## Facility Conditions Assessment Questions & Answers

**MEYDENBAUER  
CENTER**

KOHN PEDERSEN FOX  
ASSOCIATES P.C.  
ARCHITECTS

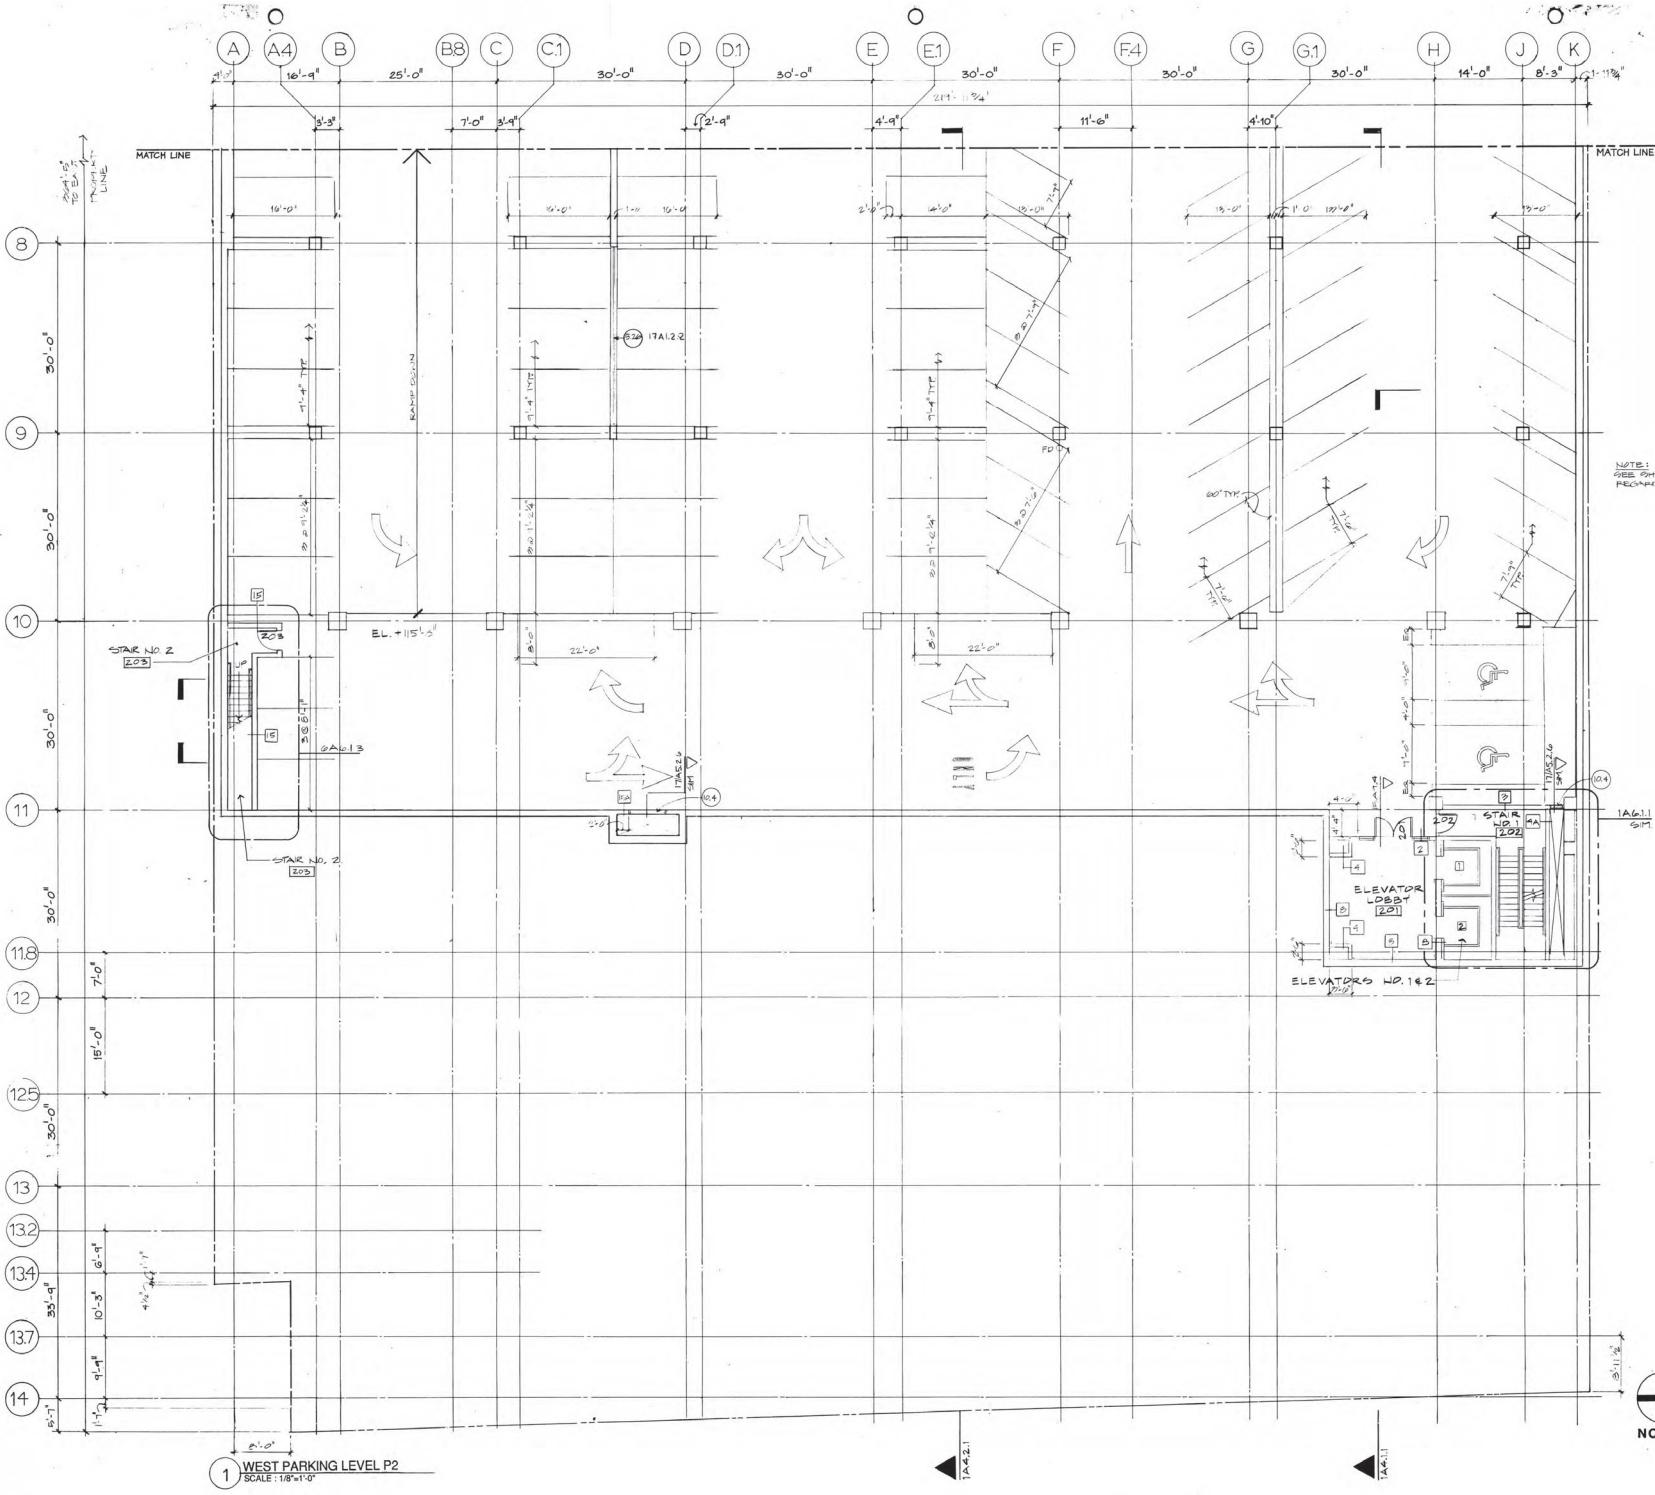
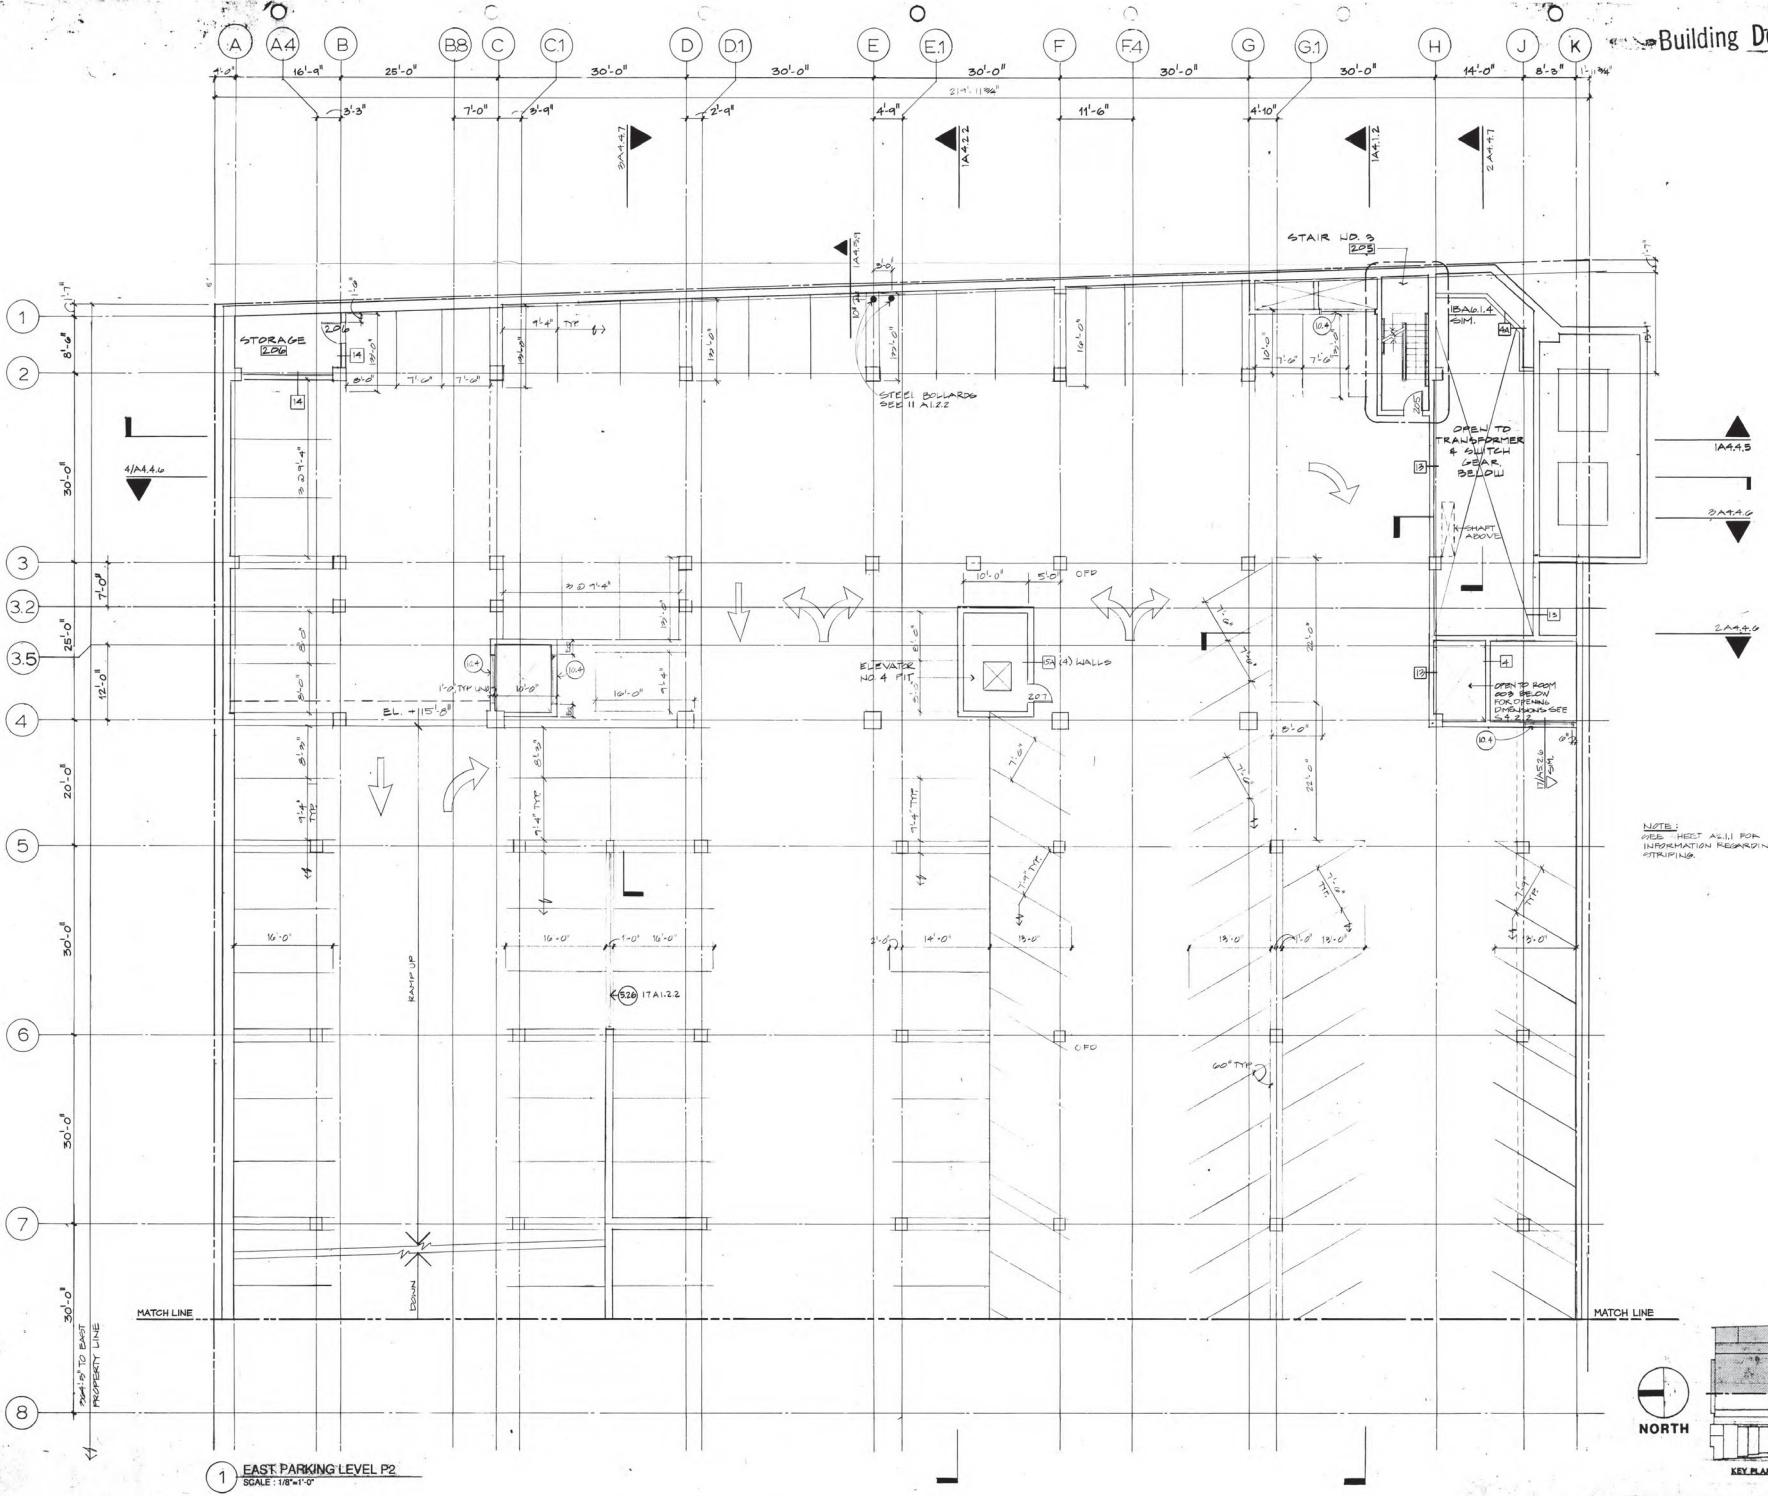
**Question:** *Would it be possible to obtain some sort of floor plans of the facility to better understand the overall layout.*

**Answer:** Included in this packet are some of the original as-builts by floor to give you a sense of the layout.
